ENGINEER'S ADDENDUM NO. 01
TO THE BID DOCUMENTS (PLANS AND SPECIFICATIONS) FOR
Beaver Creek Clean River Project Phase III – Beaver Creek Diversion Tunnel
AWB Contract # 3-G
City of Albany
Albany County, New York
October 14, 2020

C-101 – WORKING SHAFT SUPPORT OF EXCAVATION DESIGN REQUIREMENTS

C-102 – TUNNEL/PIPE PLAN AND PROFILE

BEAVER CREEK CLEAN RIVER PROJECT
PHASE III - BEAVER CREEK DIVERSION TUNNEL

C-101

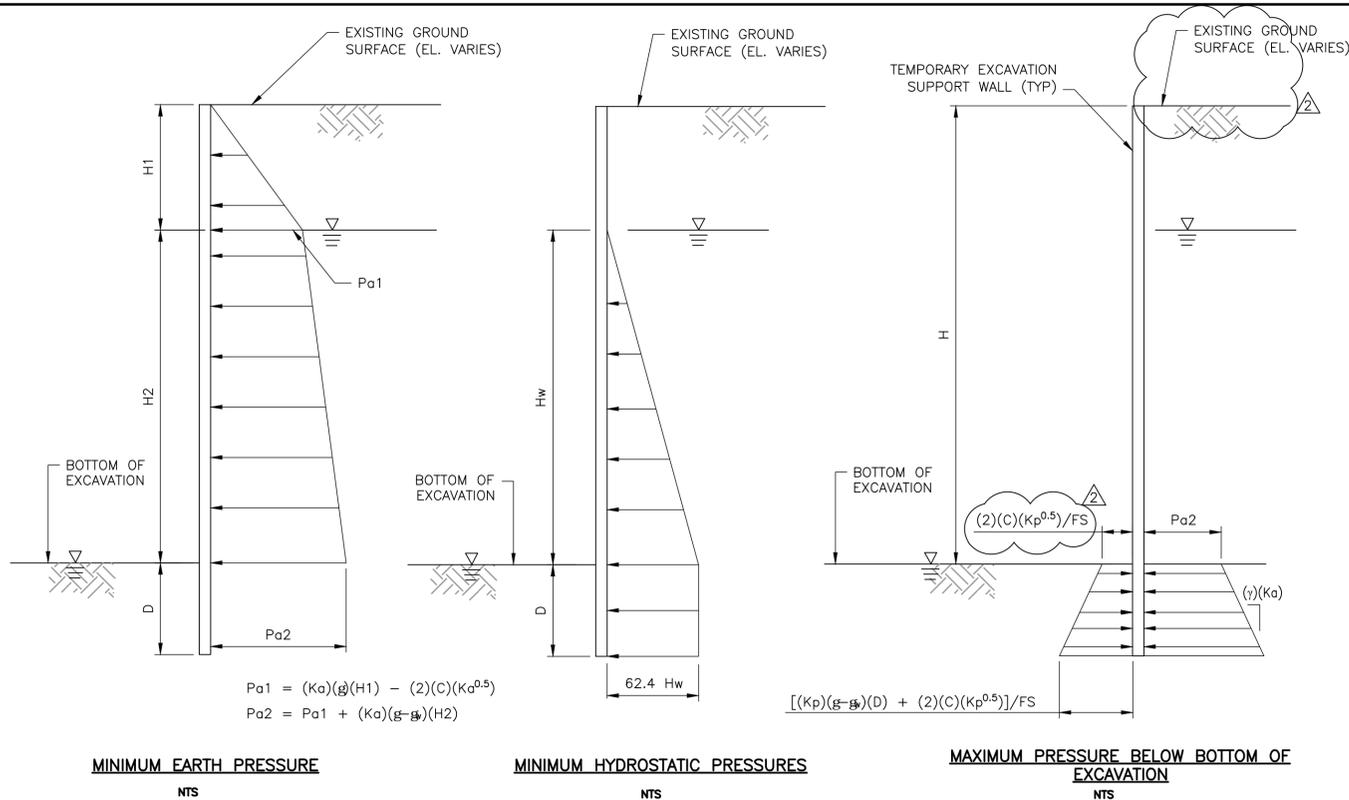
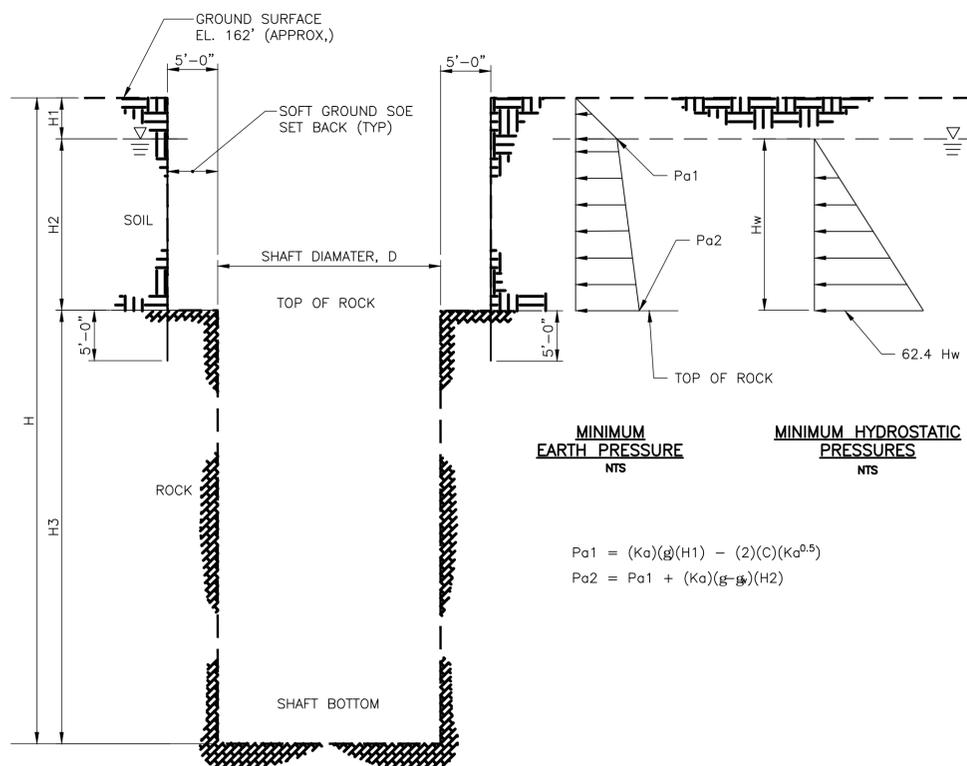
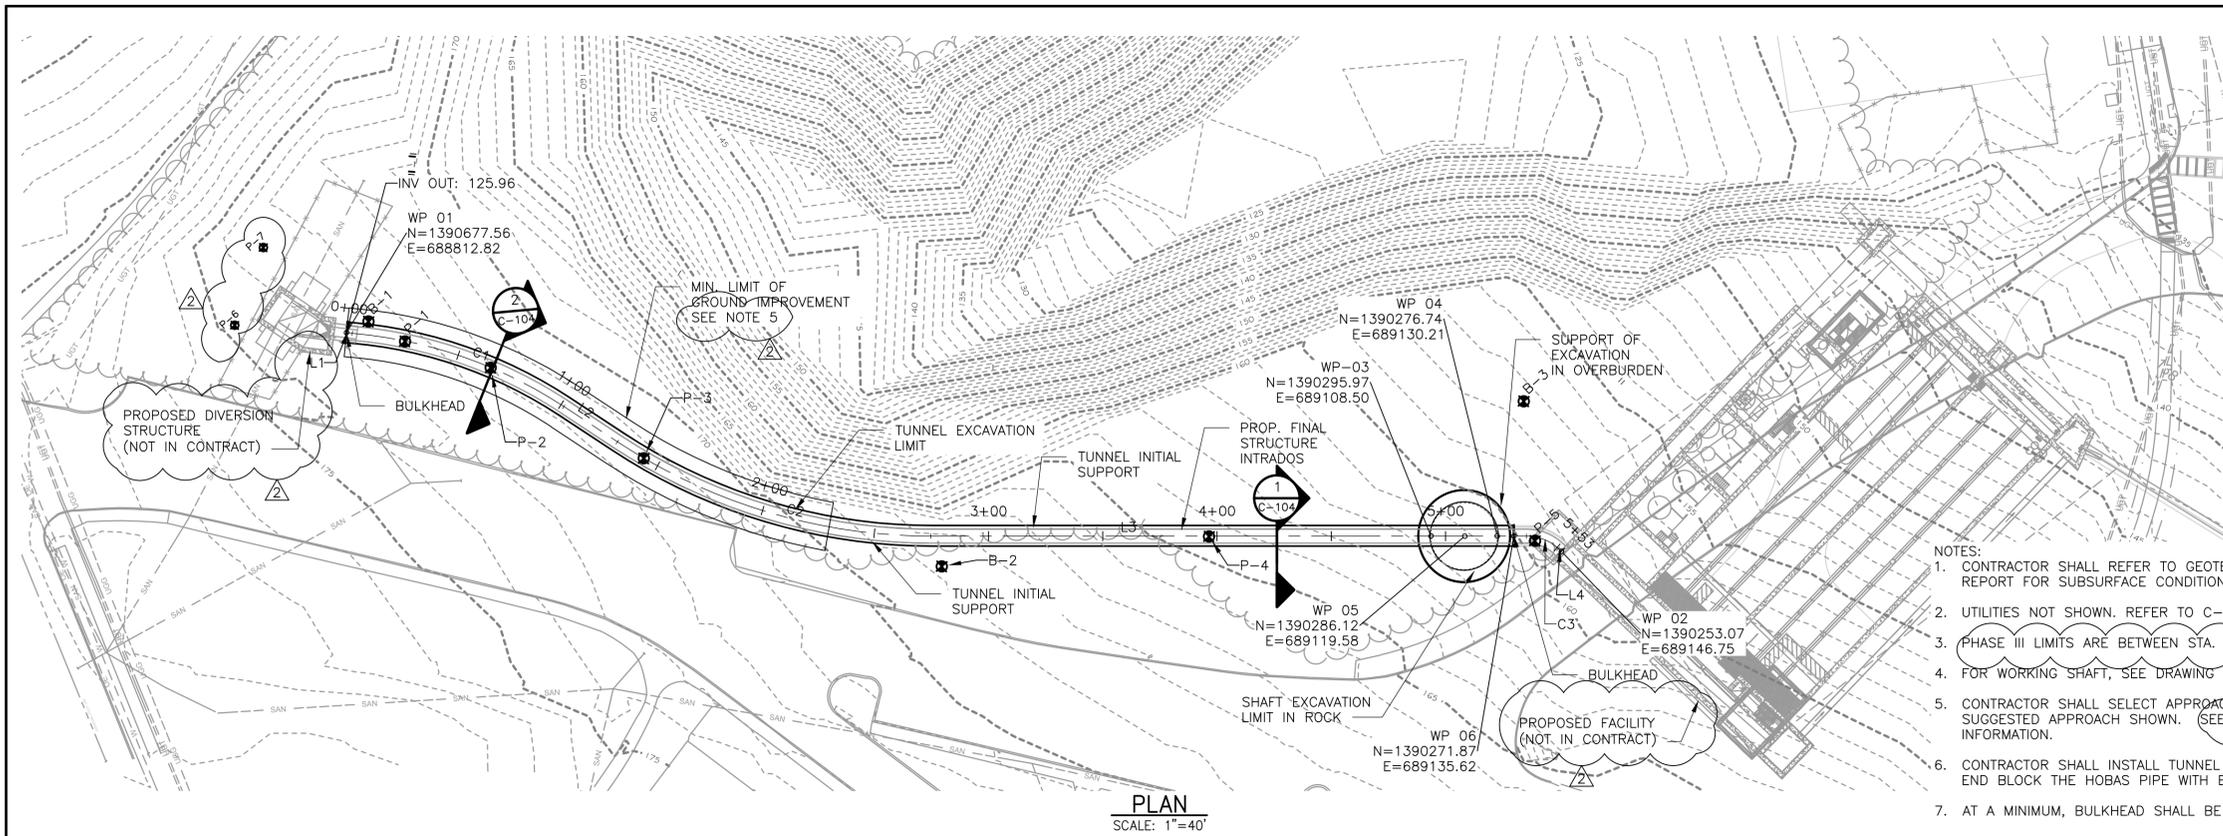
1. DETAIL A, MAXIMUM PRESSURE BELOW BOTTOM OF EXCAVATION
 - a. Passive pressure nomenclature typographical error corrected for the variable Kp. It now read $Kp^{0.5}$ instead of $KP^{0.5}$.
 - b. Leader pointing position adjusted for the note “EXISTING GROUND SURFACE (EL. VARIES)”
2. GENERAL NOTES
 - a. Added Note 6. It reads “CONTRACTOR SHALL USE THE DESIGN PARAMETERS SPECIFIED, OR VALUES INTERPRETED BY CONTRACTOR’S ENGINEER, WHICHEVER IS MORE CONSERVATIVE, TO DEVELOP THE DRIVING AND RESISTING PRESSURES.”
 - b. Added Note 7. It reads “CONTRACTOR SHALL REFER TO THE GEOTECHNICAL BASELINE REPORT AND THE GEOTECHNICAL DATA REPORT FOR SUBSURFACE STRATA INFORMATION.”

C-102
SHEET 14 OF 18

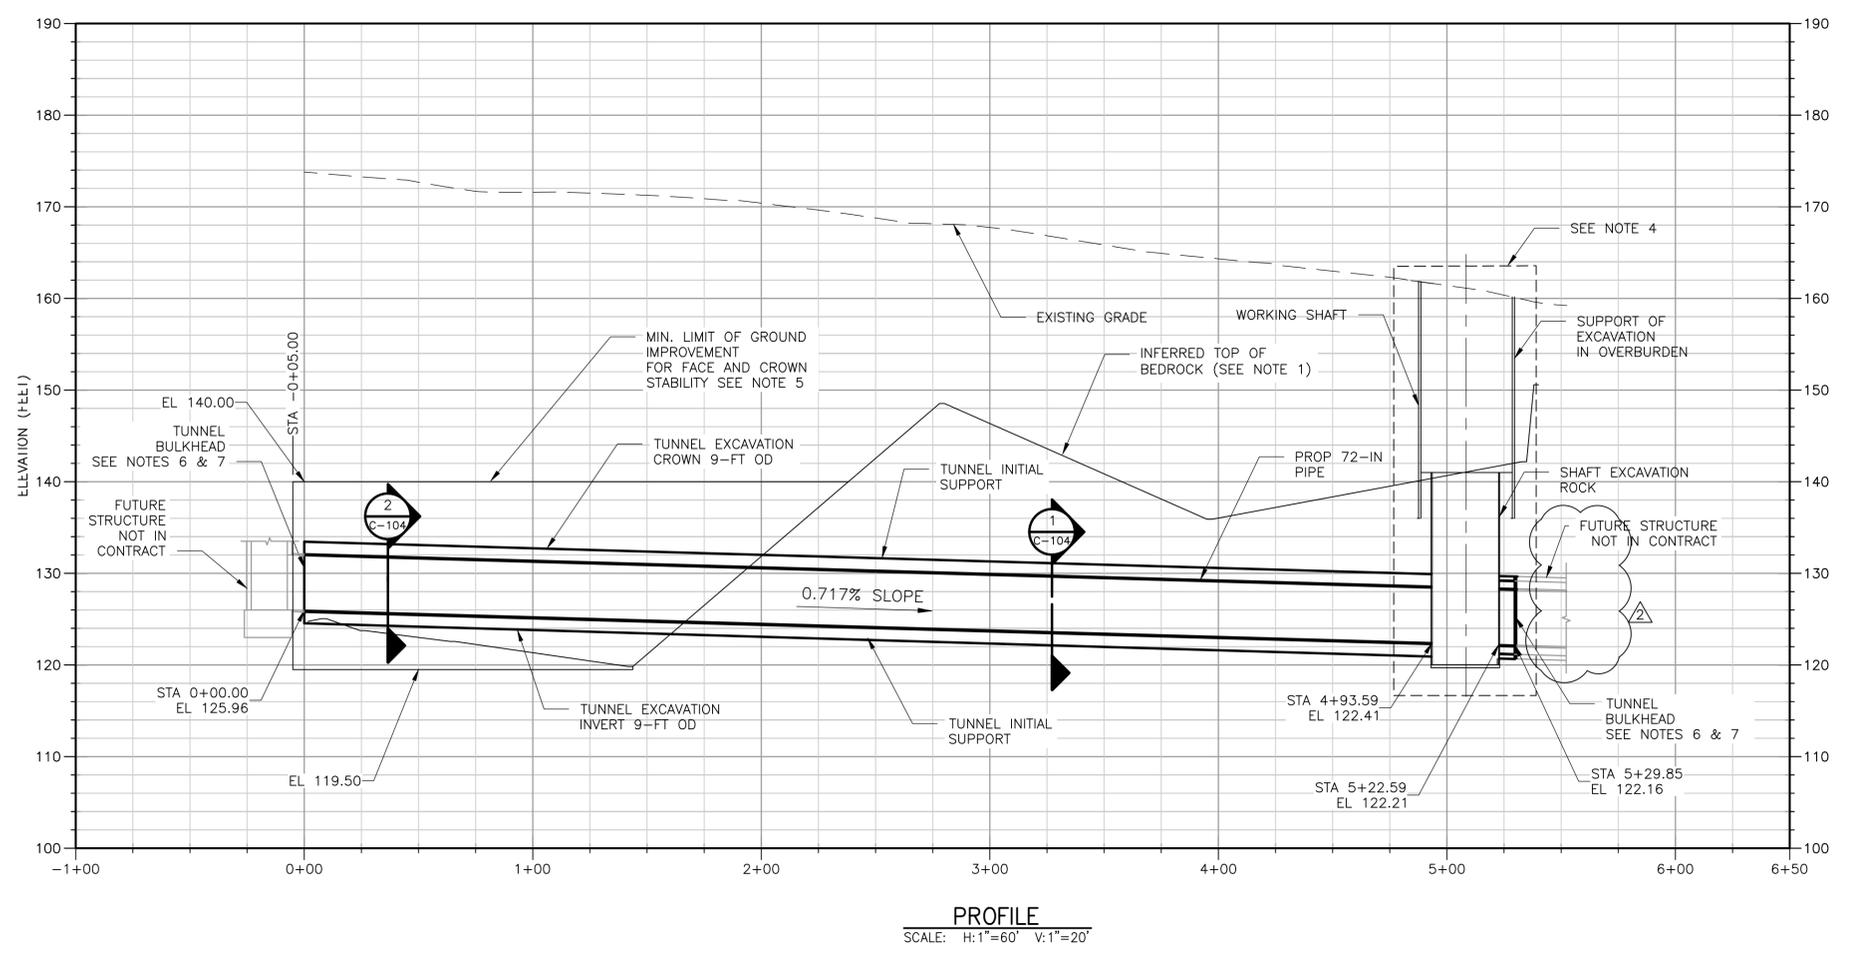
1. GENERAL
 - a. Drawing storage location, x-reference storage locations, etc. delete – on left of drawing border.

2. PLAN
 - a. Added location of probe P-6.
 - b. Added location of probe P-7.
 - c. Leader “MIN. LIMIT OF GROUND IMPROVEMENT” modified to read “MIN. LIMIT OF GROUND IMPROVEMENT SEE NOTE 5”.
 - d. Added leader “PROPOSED DIVERSION STRUCTURE (NOT IN CONTRACT)”.
 - e. Added leader “PROPOSED FACILITY (NOT IN CONTRACT)”
3. NOTES
 - a. Note 3 “VERTICAL SCALE EXAGGERATED BY A FACTOR OF 4.0”, replaced with “PHASE III LIMITS ARE BETWEEN STA. 0+00 AND STA. 5+29.85.”
 - b. Note 5, second sentence modified from “SEE SPECIFICATIONS FOR ADDITIONAL INFORMATION.” to read “SEE DWG C-105 AND SPECIFICATIONS FOR ADDITIONAL INFORMATION.”
4. PROFILE
 - a. Breakline added at right end of the profile.

PROPOSED 72-IN PIPELINE PLAN AND PROFILE
FIGURE 3-1

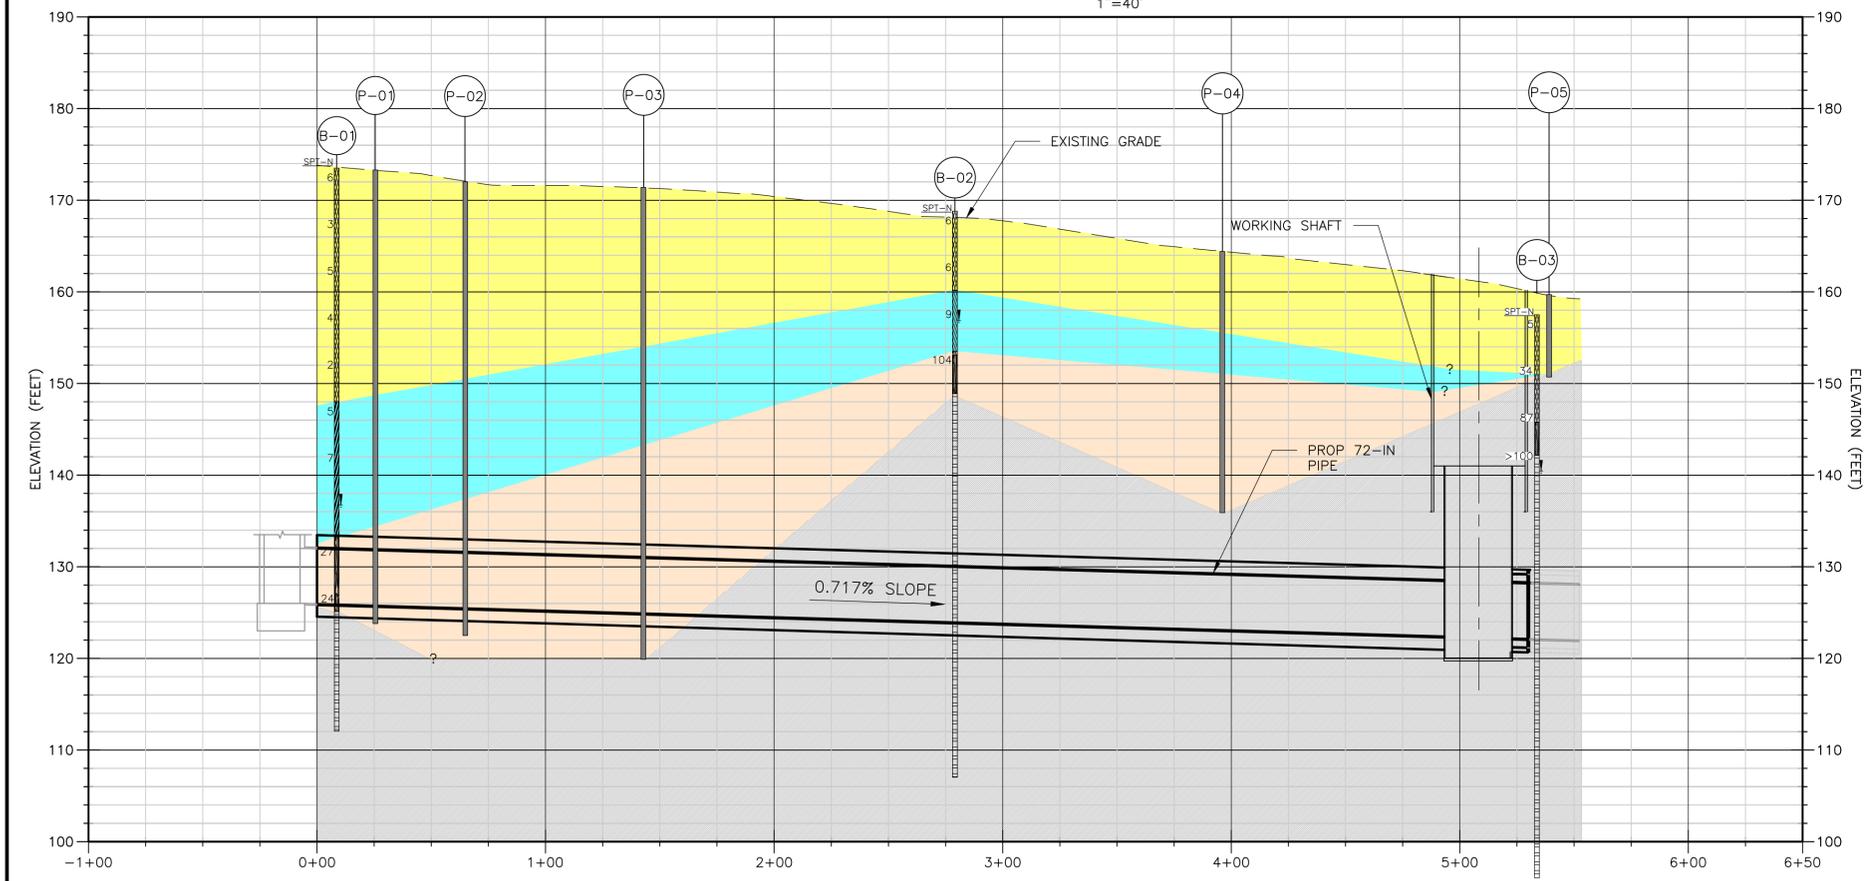
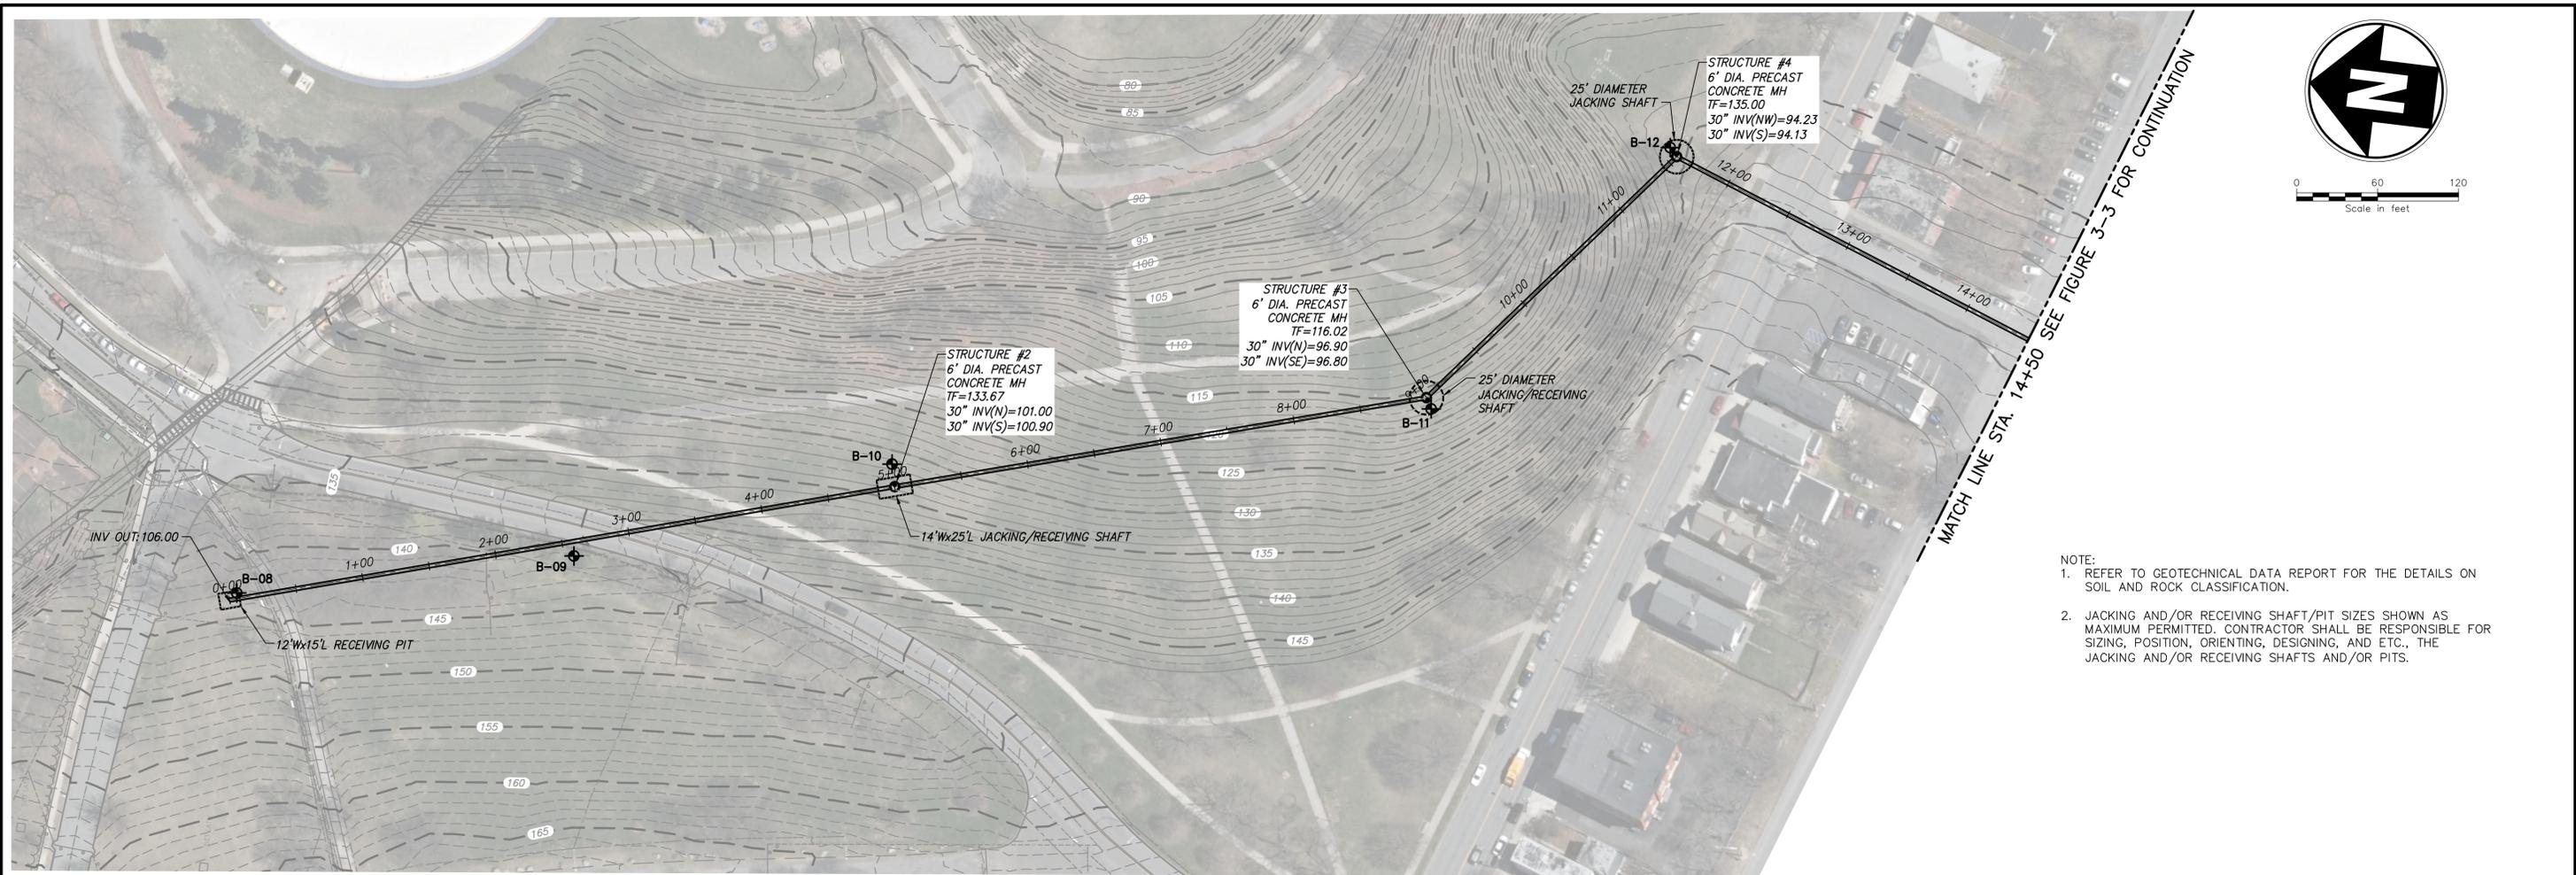
21. **Section 4.5.1 72-inch Tunnel**, deleted.
 22. Figure 3-1 updated and included as part of the GBR document. See separate attached figure that show clouds where the modifications were made.
